Contract #: 04-0120F4
 Cty: SF/ALA Rte: 80 PM: 13.2/13.9
 File #: 69.25B

QUALITY ASSURANCE -- NON-CONFORMANCE REPORT

NCR #: ZPMC-0648

Reference Description: Side Panel to Open Rib Stiffener welds

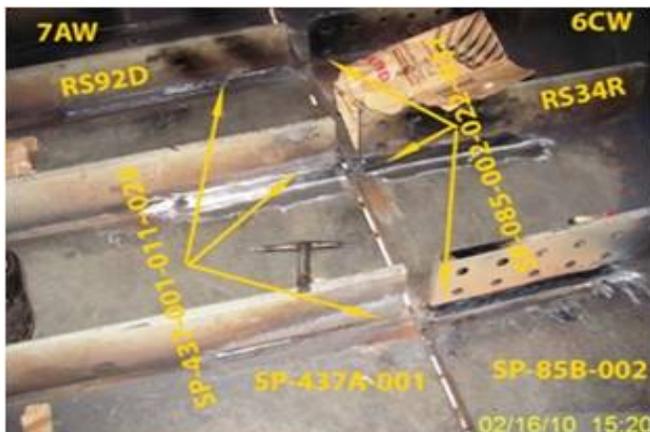
During random in-process inspection of Orthotropic Box Girder (OBG) segments 6CW and 7AW, this Quality Assurance Inspector (QA) discovered the following issues:

- ZPMC has deviated from the approved weld joint design without the Engineers approval.
 - ZPMC personnel installed Complete Joint Penetration (CJP) welds in lieu of fillet welds as detailed on approved shop drawings SP085 and SP437.
 - The affected joints in segment 6CW are identified as SP085-002-022~031.
 - The affected joints in segment 7AW are identified as SP437-001-011~020.
 - The welds are located in between Panel Point 47 (PP47) and PP48 on the Crossbeam side.
 - The welds in question are at the hold back locations joining RS34R Open Rib Stiffeners to Side Panel SP085B-002 on segment 6CW, and the RS92D Open Rib Stiffeners to Side Panel SP437A-001 on segment 7AW.
 - OBG Segments 6CW and 7AW are located in the OBG Trial Assembly Yard.
- For further information, please see the pictures below.

AWS D1.5-2002 section 6.5.1; “The Inspector shall make certain that the size, length, and location of all welds conform to the requirements of this code and to the detail drawings and that no unspecified welds have been added without approval”.

AWS D1.5 2002 section 3.7.4 “Prior approval of the Engineer shall be obtained for repairs to base metal (other than those required by 3.2), repair of major or delayed cracks, repairs to ESW and EGW welds with internal defects, or for a revised design to compensate for deficiencies.”

Reference Resolution: ZPMC has received approval to change the weld joints into complete joint penetration welds. Attached is NDT documentation to show that the welds are acceptable.

This proposed resolution is acceptable. The documentation received is sufficient and the Department concurs that Non-Conformance ZPMC-0648 is closed.

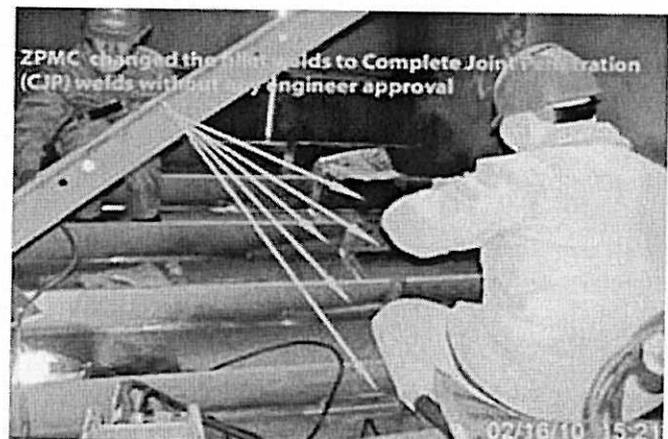
During random in-process inspection of Orthotropic Box Girder (OBG) segments 6CW and 7AW, this Quality Assurance Inspector (QA) discovered the following issues:

- ZPMC has deviated from the approved weld joint design without the Engineers approval.
- ZPMC personnel installed Complete Joint Penetration (CJP) welds in lieu of fillet welds as detailed on approved shop drawings SP085 and SP437.
- The affected joints in segment 6CW are identified as SP085-002-022~031.
- The affected joints in segment 7AW are identified as SP437-001-011~020.
- The welds are located in between Panel Point 47 (PP47) and PP48 on the Crossbeam side.
- The welds in question are at the hold back locations joining RS34R Open Rib Stiffeners to Side Panel SP085B-002 on segment 6CW, and the RS92D Open Rib Stiffeners to Side Panel SP437A-001 on segment 7AW.
- OBG Segments 6CW and 7AW are located in the OBG Trial Assembly Yard.

AWS D1.5-2002 section 6.5.1; "The Inspector shall make certain that the size, length, and location of all welds conform to the requirements of this code and to the detail drawings and that no unspecified welds have been added without approval".

AWS D1.5 2002 section 3.7.4 "Prior approval of the Engineer shall be obtained for repairs to base metal (other than those required by 3.2), repair of major or delayed cracks, repairs to ESW and EGW welds with internal defects, or for a revised design to compensate for deficiencies."

Document locations of weld type changes and perform NDT required to verify weld quality.

Contractor submitted request to change joint type after work was complete, and supplied post repair NDT reports verifying the welds in question are in conformance with the Contract weld quality requirements.
